Product Change Notification / GBNG-14UHSW677

CCB 4214.001 Final Notice: Qualification of MMT as a new assembly site for selected MSCC LX3302Axxx and LX34050xxx device families available in 14L TSSOP (4.4mm) package.

PRE AND POST CHANGE SUMMARY

Lead Frame Comparison

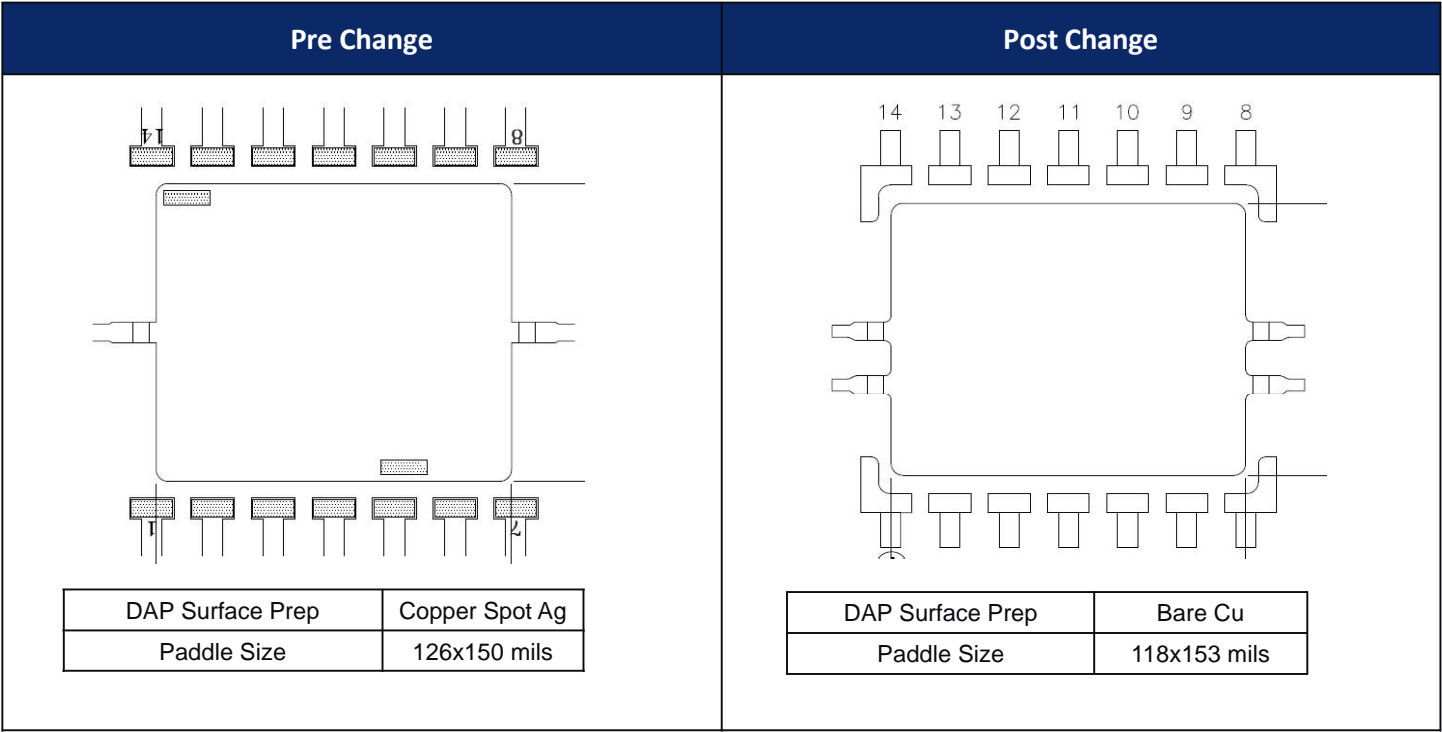
Pre Change	Post Change
Assembly Site		UTAC Thai Limited (UTL-1) LTD. (NSEB)	Microchip Technology Thailand - Branch (MMT)
Wire material		PdCu	Au
Die attach material		8200T	2200D
Molding compound material		G605L	G600V
Lead frame	Material	C7025	C7025
	DAP Surface Prep	Copper Spot Ag	Bare Cu
	Paddle Size	126x150 mils	118x153 mils
